TSG RAN WG1#6
Epsoo, Finland
13-18 July 1999

TSGR1#6(99)796

Source: Golden Bridge Technology
Title: Proposed CPCH-related changes to 25.214: Physical Layer Procedures (FDD)
Document for: Approval
Agenda Item: Ad-hoc 14

Figure 30: Timing of PCPCH and AICH transmission as seen by the UE, with AICH transmission

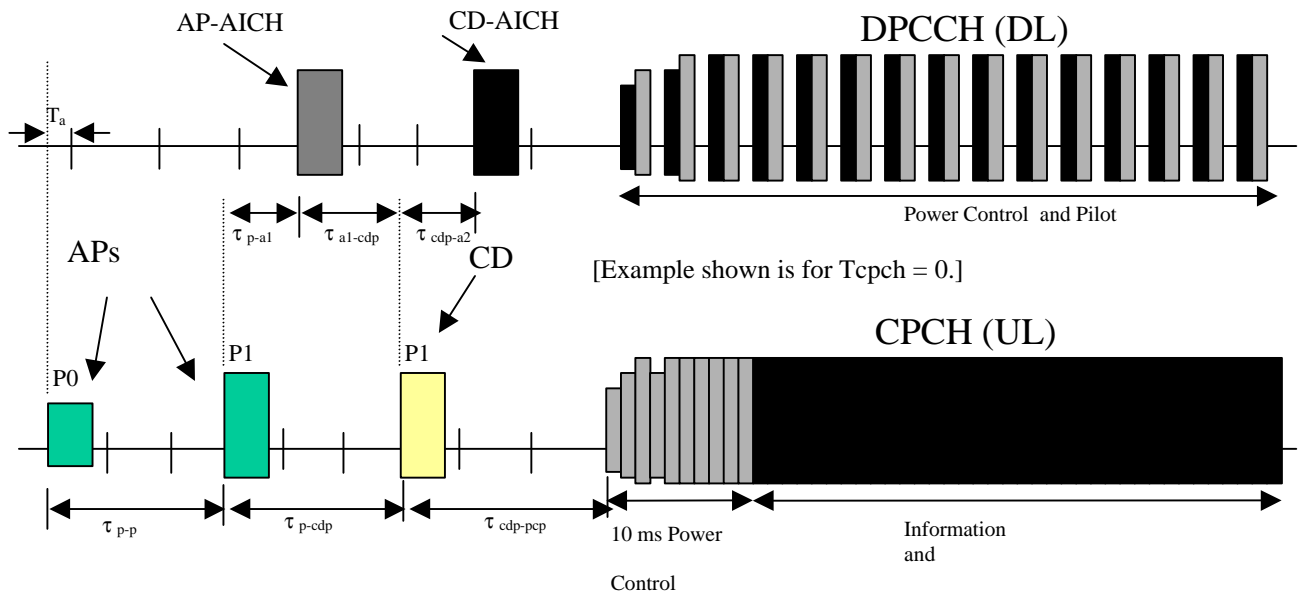
Add a new section 6.2 titled: “CPCH Physical Layer Access Procedures”:**6.2 CPCH Random Access Procedures (new section)**

Figure 30 shows the timing of the CPCH uplink transmission with the associated DPCCH control channel in the downlink.
